NRL Report No. B-1767

Report of Test

Horns, Types H-8 and H-9

Benjamin Electric Manufacturing Company,
Des Plaines, Illinois

PLATE 3

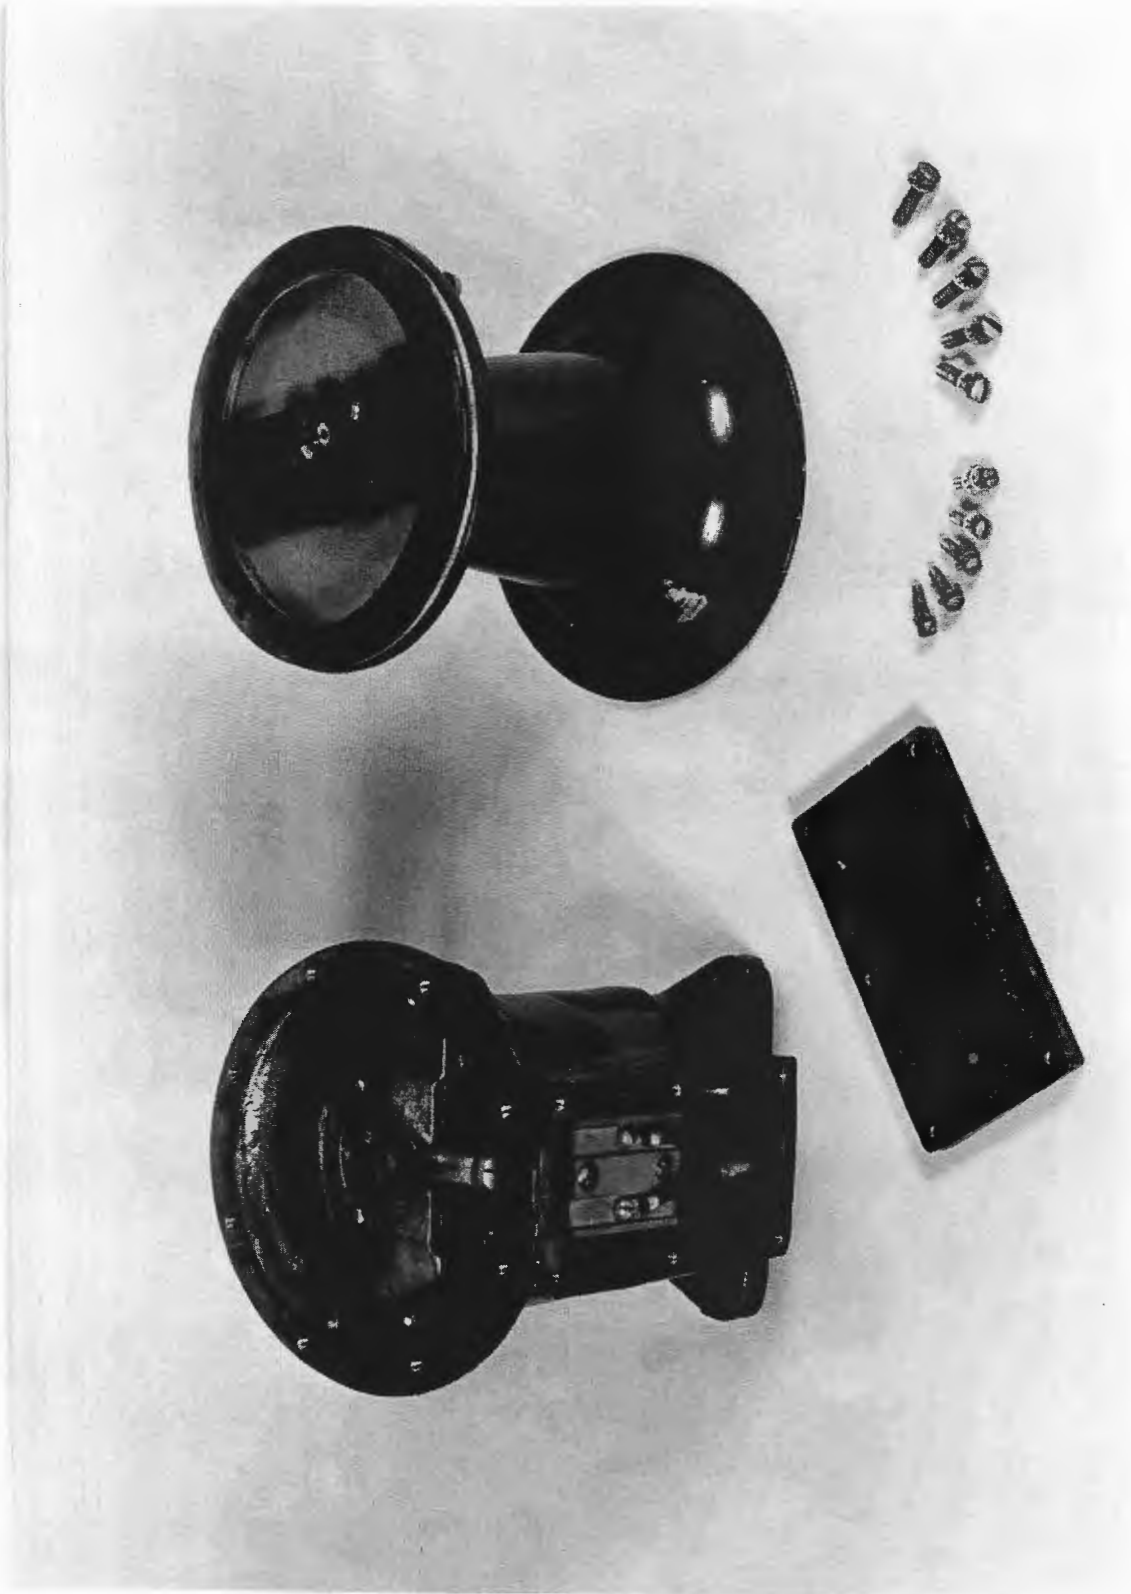
8. These horns differ from those reported by reference (d), in that the anvil is not mounted on the diaphragm. The anvil is riveted to a laminated strip of spring steel, the ends of which are clamped between two rubber gaskets located between a steel ring and the case flange. A hammer button, secured to the opposite side of the strip with the same rivets, strikes the diaphragm when the anvil is struck by the ratchet on the armature.

- (3) Endurance - Failed after 27 hours due to an open circuit in the armature. When the horn was examined, two of the rivets (pc. 48) securing the anvil (pc. 46) to spring strip (pc. 45) had fallen out.

(b) It is further recommended that the manufacturer be invited to experiment with a formed type of diaphragm with the anvil riveted to the diaphragm. It is believed that this type of construction would result in fewer diaphragm failures and the production of a note of higher quality.
